MISSISSIPPI POWER & LIGHT COMPANY

SUBJECT: Grand Gulf Nuclear Station
Units 1 and 2
Docket Nos. 50-416 and 50-417
License No. NPF-13
File 0260/0272/L-860.0
Final Information to Close
Humphrey Concerns
AECM-82/574

Attachment 1 to this letter contains the balance of the information which Mississippi Power & Light Company (MP&L) committed in reference 1 to submit to your staff. This information completes the program which MP&L undertook to respond to the design questions raised by Mr. John Humphrey.

## ATTACHMENT 1

FIGURE 34-4

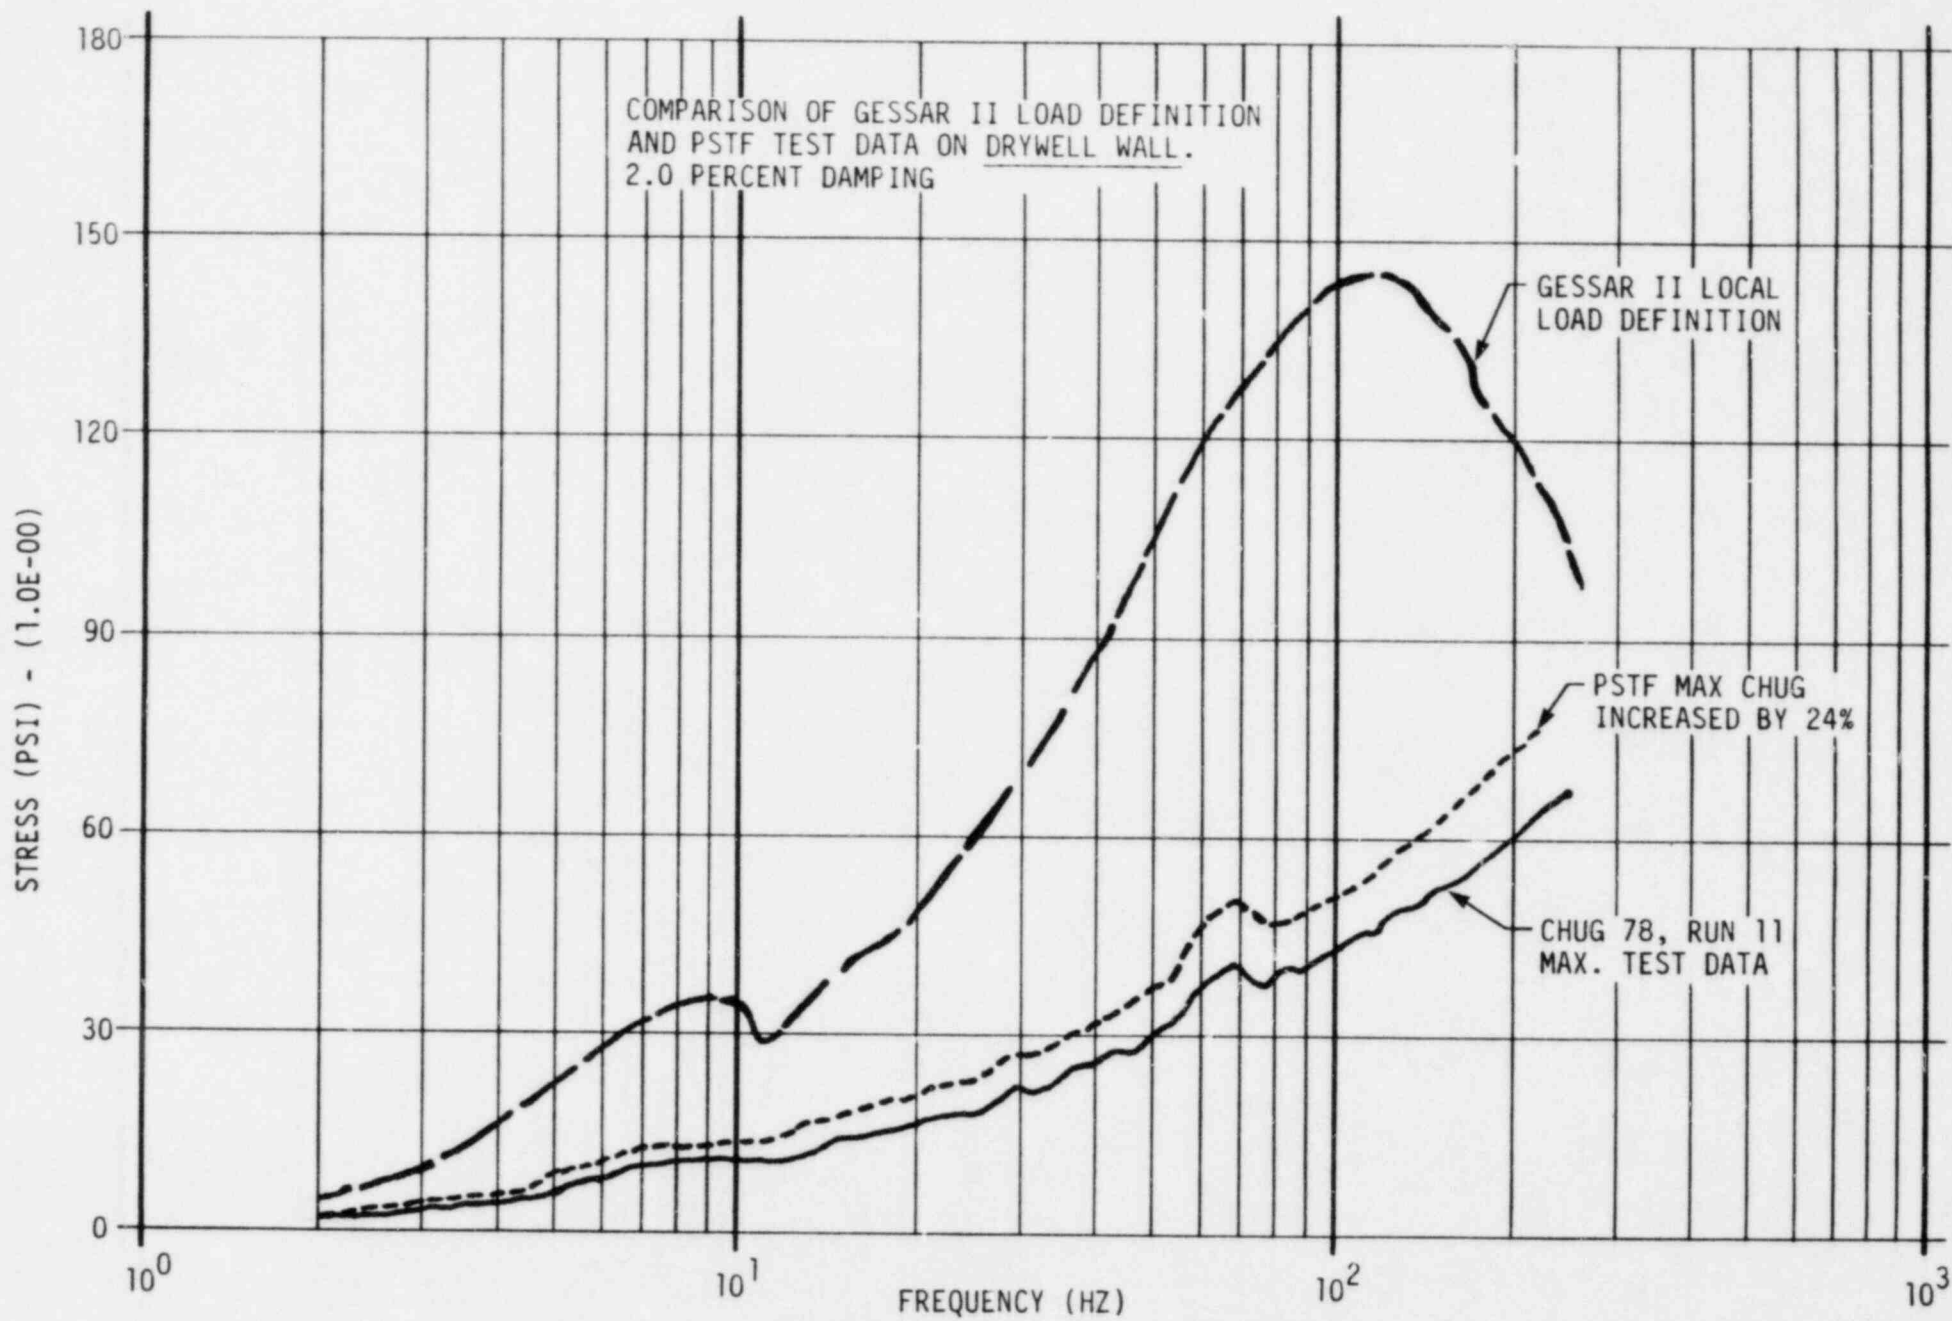
Local load comparison plots are shown in Figures 34-4 through 34-6 for the three suppression pool boundary areas. Figure 34-4 shows the original drywell load definition easily bounds the increased loads for all frequencies. Figure 34-5 indicates slight load exceedance on the containment wall from 15 Hz to 32 Hz. From this plot, it is apparent that the total load definition area (indicative of energy) easily bounds that of the increased maximum chug load. In addition, the exceedance is judged to be negligible due to the degree of conservatism employed in developing the increased chug loading response.

FIGURE 34-6

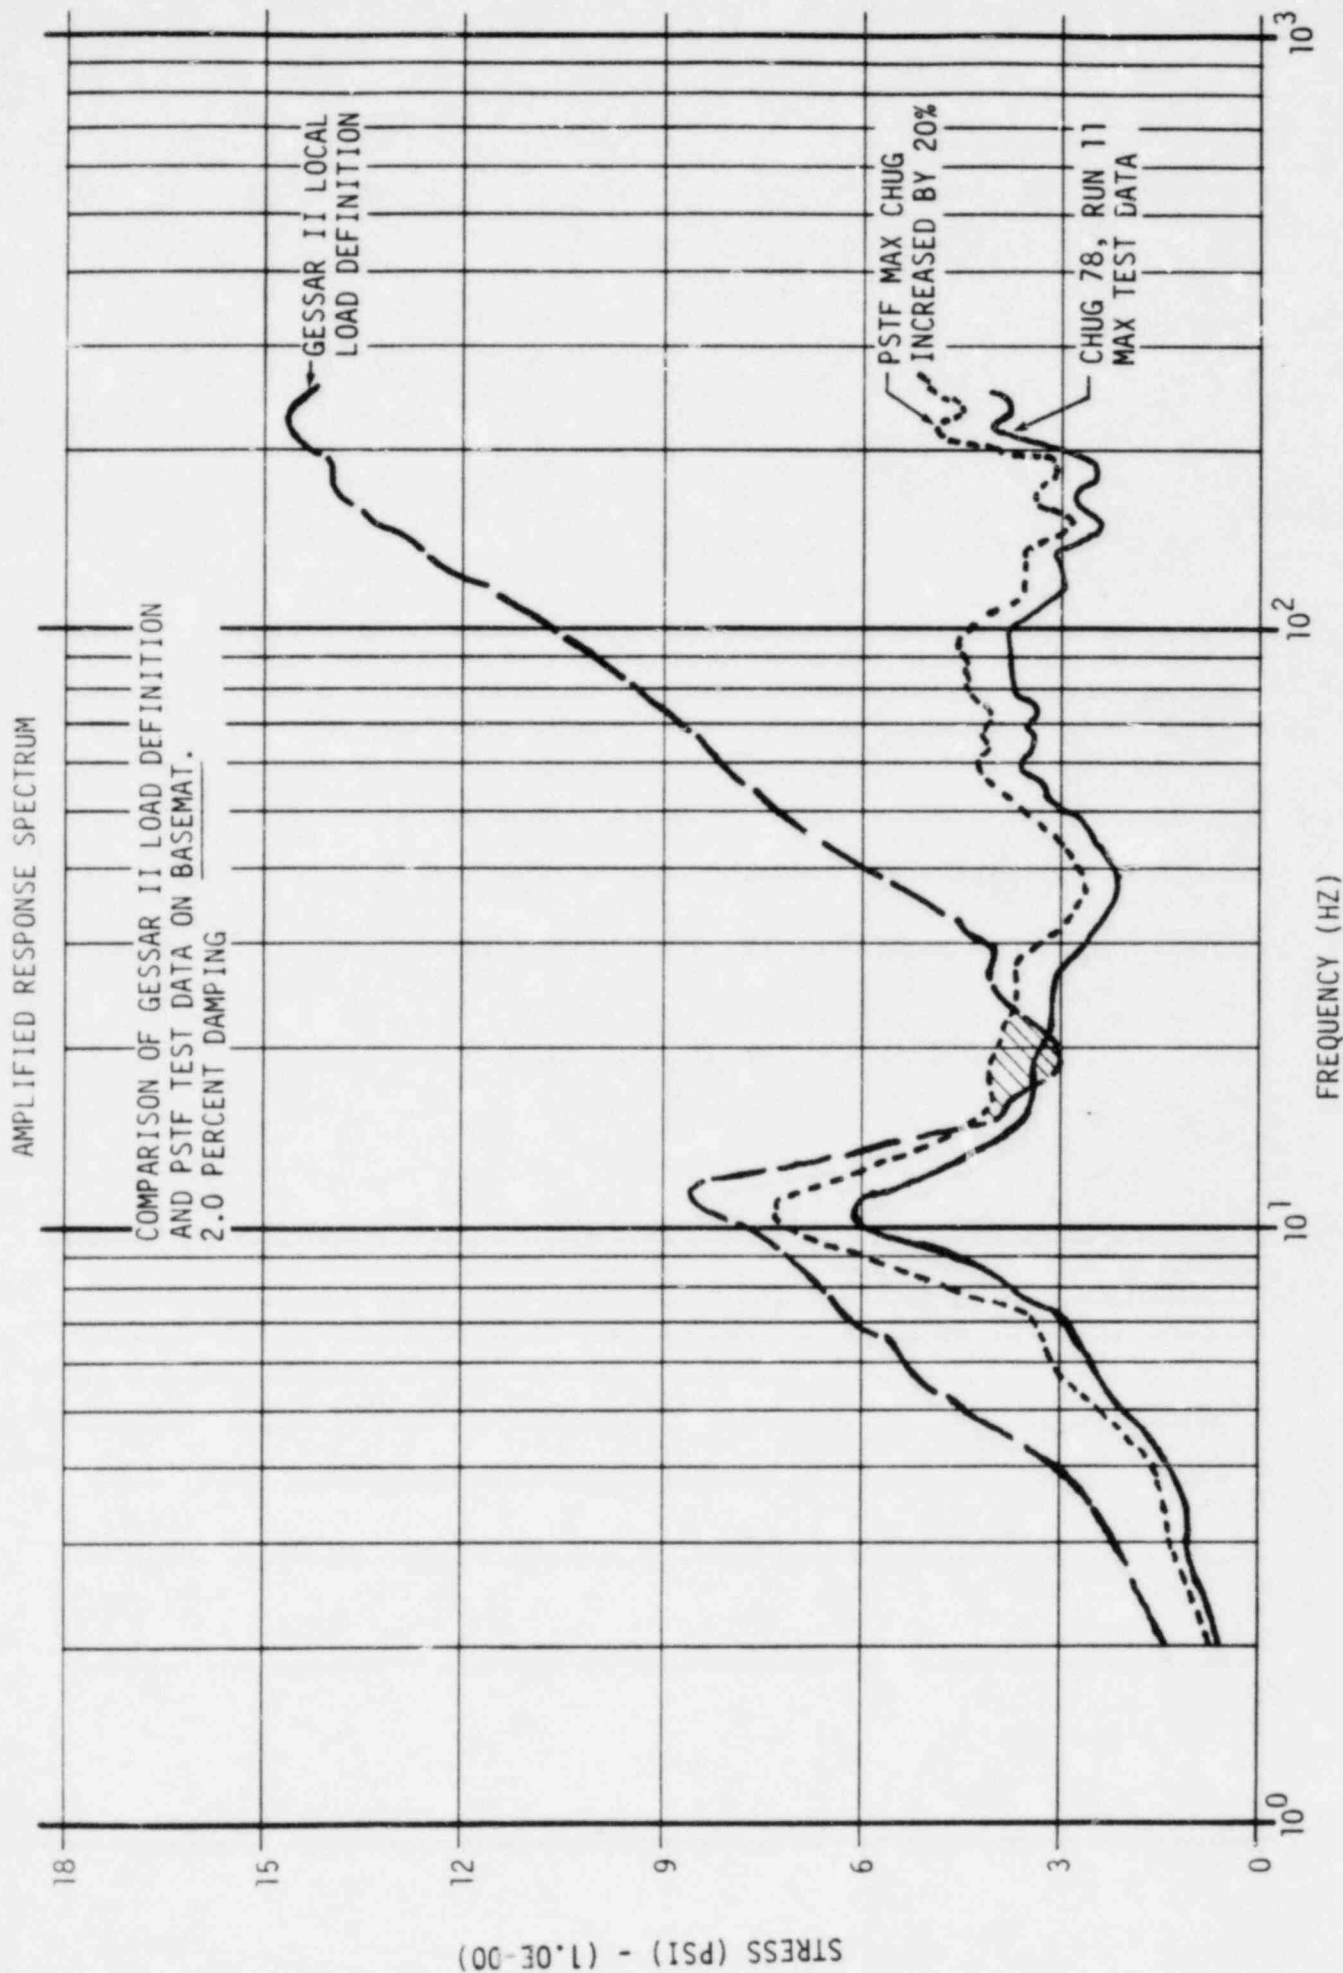
Finally, Figure 34-6 indicates up to a 35% load exceedance in the frequency range of 15 Hz to 22 Hz on the basemat boundary. This exceedance is also negligible by the same reasoning as that applied in evaluating the exceedance shown in Figure 34-5. In addition, the hydrostatic head of the suppression pool on the basemat insures that a negative pressure will never be imposed on the liner. Therefore, since the liner is backed by concrete, no natural modes of vibration are excitable.
